Modification of Minister's Approval

Section 75W of the *Environmental Planning and Assessment Act 1979*

Development Approval:	MP 05_0037 granted by the Minister for Planning on 4 July 2006
For the Following:	Construction and operation of a waste oil Resource Recovery and Recycling Facility
Applicant:	Cleanaway
Consent Authority:	Minister for Planning
The Land:	Lot 223 DP1037300, 11 Kyle Street, Rutherford, Maitland Local Government Area
Modification:	MP 05_0037_MOD 5: the modification includes: Construction and operation of new equipment (oil polishing system, multi-fuel burner, six additional oil storage tanks with total combined storage of 2.4 ML and safety and fire-fighting systems) and increase the height of the Multi-Fuel Burner Stack, to enable the facility to produce both Class I and Class II product oils.

FILE NAME	4090 151007 Polishing Proposal_RevD.dwg	SHEET	1 of 1	SCALE	not to scale
SIZE					
DRAWN	1 Dec 2015				Rutherford NSW Polish project
CHECK					
APPR					CONCEPT - For development application
ISSUED					
REV	D - draft	DWG NO	4090 revD - DRAFT		
CONTRACT NO

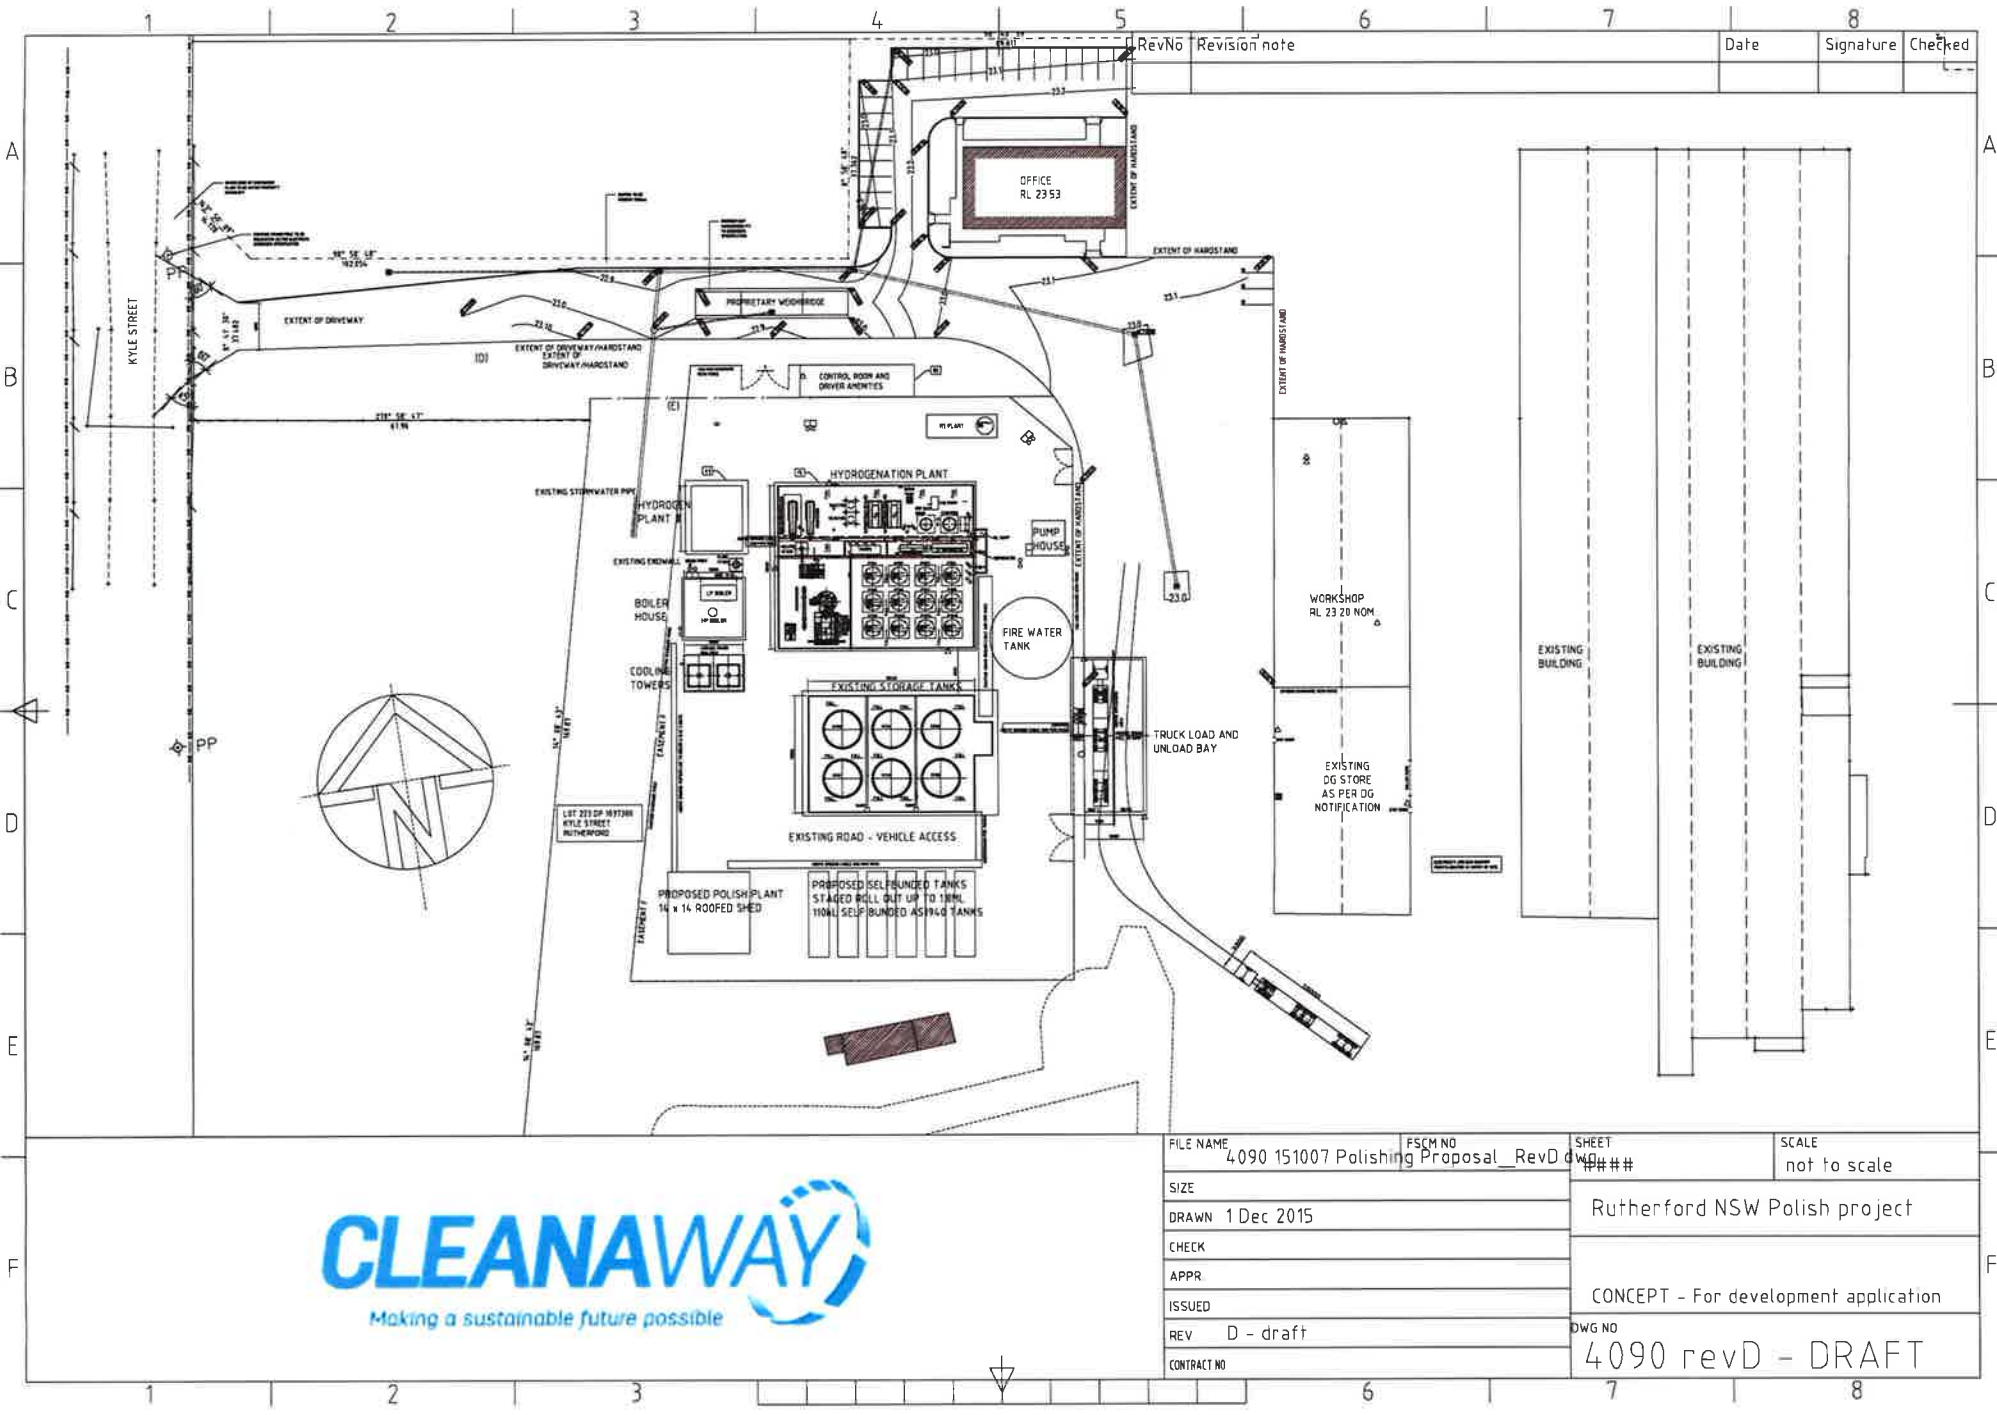
- (o) Replace the site layout plan at Appendix A with Drawing Number 4090 Rev D, dated 1 December 2015
